CITY OF GARDEN CITY

STAFF REPORT

File Number: SUBFY2024 - 0006, Edgemere Subdivision
For: Combined Preliminary Plat and Planned Unit Development
A 10 residential and 1 common lot subdivision
Location: 219 E. 44th Street
Applicant: Jadon Schnider
Report Date:
Design Review: November 18, 2024

Figure 1.

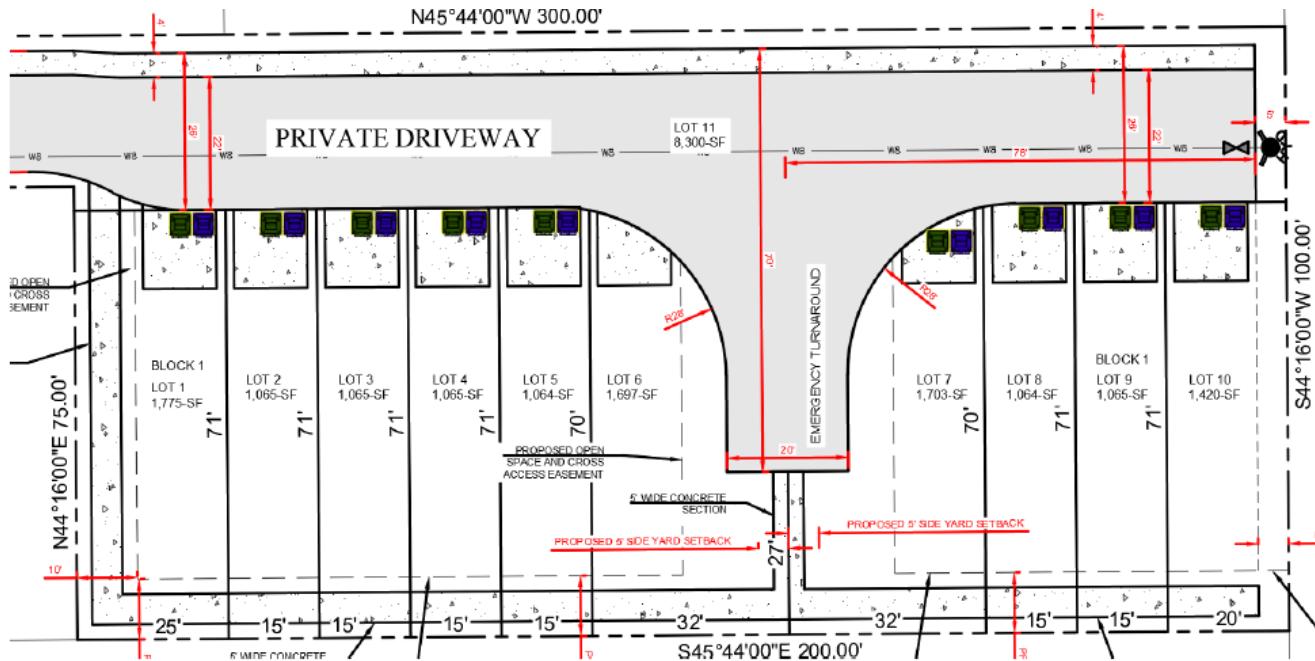
<u>Improvement Standards</u>			Table 8-4D-1: MINIMAL DIMENSIONAL STANDARDS FOR MOTOR VEHICLE STALLS <table border="1"> <thead> <tr> <th><u>Parking Angle</u></th><th><u>Stall Width</u></th><th><u>Stall Depth</u></th><th><u>Length Per Car</u></th><th><u>Driveway Width*</u> Must also meet fire requirements</th></tr> </thead> <tbody> <tr> <td><u>90°</u></td><td><u>9'0"</u></td><td><u>20'0"</u></td><td><u>9'0"</u></td><td><u>22'0"</u></td></tr> </tbody> </table>				<u>Parking Angle</u>	<u>Stall Width</u>	<u>Stall Depth</u>	<u>Length Per Car</u>	<u>Driveway Width*</u> Must also meet fire requirements	<u>90°</u>	<u>9'0"</u>	<u>20'0"</u>	<u>9'0"</u>	<u>22'0"</u>
<u>Parking Angle</u>	<u>Stall Width</u>	<u>Stall Depth</u>	<u>Length Per Car</u>	<u>Driveway Width*</u> Must also meet fire requirements												
<u>90°</u>	<u>9'0"</u>	<u>20'0"</u>	<u>9'0"</u>	<u>22'0"</u>												
Compliant Parking Provided: <u>10 regular parking spaces</u> Stall Width: 10' Length per car: 35' The applicant has provided conflicting information about the garage's car capacity. Based on dimensional standards, the garage can accommodate only one car. Additionally, the dimensions of the driveway are not indicated on the site plan.																
<u>8-4D-4 Parking Use Standards</u>	DC/CC	No compliance issues noted	A. Number Of Spaces: No use shall provide less than the minimum spaces required by this article. B. Use Of Property; Phased Projects: The use of any property is conditional upon the unqualified continuance and availability of the parking as required by this code. C. Equivalent Facilities: No required parking area or space provided, as required by this article, shall later be eliminated, reduced, or converted in any manner unless other equivalent facilities approved by the city are provided.													
<u>8-4D-5 Required Number of Off-Street Parking Spaces</u>	DC/CC	Not Compliant	In the floor plans provided, the applicant has used the same layout for all unit types. This information contradicts the description of the units. The staff cannot calculate the required number of parking spaces. For developments with more than two (2) dwelling units there shall be one-half (0.5) additional parking space/unit provided for guest parking for the first ten (10) dwelling units. The proposed plans include 10 units, which require 5 guest parking spaces. However, no guest parking spaces are provided on the site. The purpose of the driveway remains unclear because: <ul style="list-style-type: none"> For two-bedroom units, 2 parking spaces must be provided, one of which must be covered (one car garage provided). However, driveway dimensions are not provided. In correspondence with Republic Services, the applicant provided a plan in which the garbage bins for each unit would be placed on the driveway, giving the driveway a dual purpose (see Figure 1). However, the applicant has not provided dimensions or plans

that demonstrate that both cars and garbage bins can fit on the driveway.
<u>8-4D-6 Standards For Equivalent Parking Adjustments</u>	DC/CC	No compliance issues noted	Not requested
<u>8-4D-7 Off Street Loading Standards</u>	DC/CC	No compliance issues noted	None proposed
8-4E Transportation and Connectivity Provisions			
<u>8-4E-3 Public Street Connections</u>	DC/CC	Compliant as Conditioned	There is a general condition of approval requiring that all streets and driveways shall adhere to the standards of a clear vision triangle at all times. Needs to be indicated on the site plan.
<u>8-4E-4 Internal Circulation Standards</u>	DC/CC	Compliant	The drive is 20' or greater in width
<u>8-4E-5 Private Street Standards</u>	DC/CC	Not Compliant	<p>Staff are unsure if the proposed road is to be a private road. Confirmation is required.</p> <p>All private streets shall be designed and constructed to the following standards:</p> <ul style="list-style-type: none"> A. The private street shall be constructed on a perpetual ingress/egress easement or a single platted lot that provides access to all applicable properties. B. The private street shall be constructed within the easement and shall have a travel lane width of twenty six feet (26'). C. The private street shall provide sufficient maneuvering area for emergency vehicles as determined and approved by the fire authority. D. The private street name(s) shall obtain approval from the Ada County street name committee. E. A binding contract that establishes the party or parties responsible for the repair and maintenance of the private street including regulations for the funding shall be recorded with a final plat. No building permit shall be issued until the contract has been recorded. <p>The applicant also needs to reach an agreement with Boise Fire and the Ada County Highway District (ACHD) regarding the driveway and common lane requirements.</p>
